:NOTICE: Failure to acknowledge : Solicitation No. DACW45 03 B 0008
:all amendments may cause rejec- :
:tion of the bid. See FAR : Date of Issue: 25 Feb 2003
:52.214-3 of Section 00100 : Date of Opening: 27 Mar 2003

Amendment No. 0001
19 March 2003

SUBJECT: Amendment No. 0001 to Specifications and Drawings for Construction of
Modify Roadway Drain, Chatfield Project, Littleton, CO
Solicitation No. DACW45 03 B 0008.

GEOTEXTILE AND SUBDRAIN DETAIL

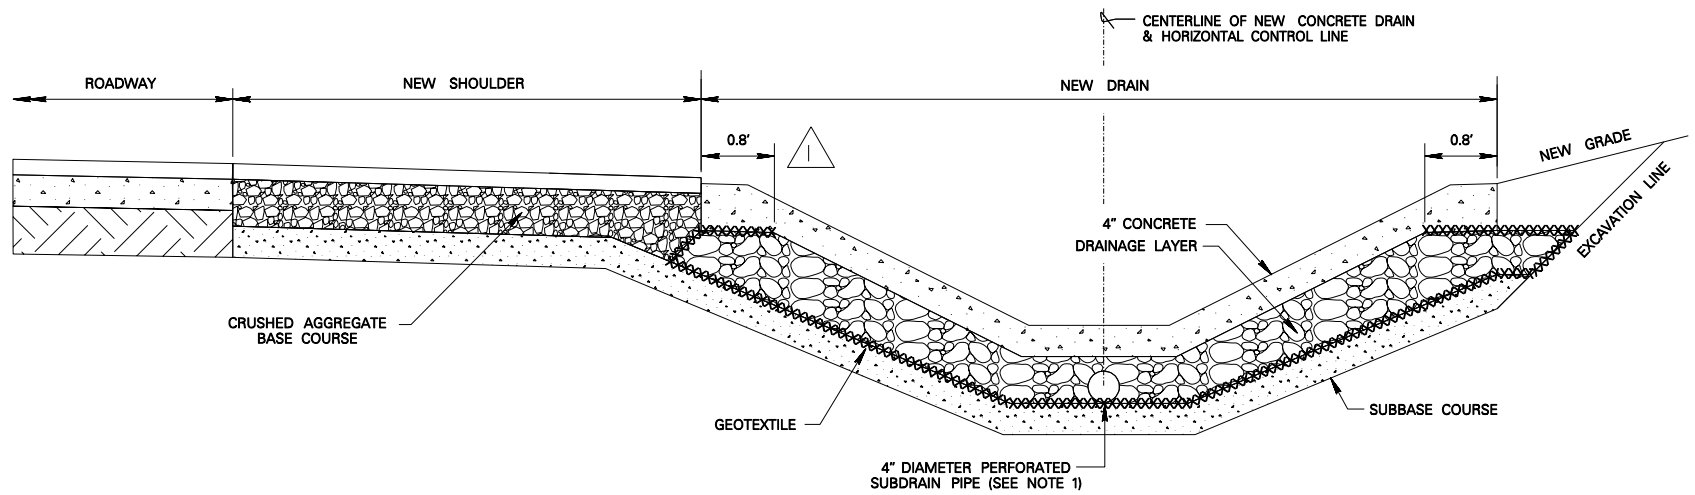
(1) Dwg. PC52-400E12, Sheet B8.03, Revised geotextile location on GEOTEXTILE AND SUBDRAIN DETAIL in upper left of sheet. See attached sheet.
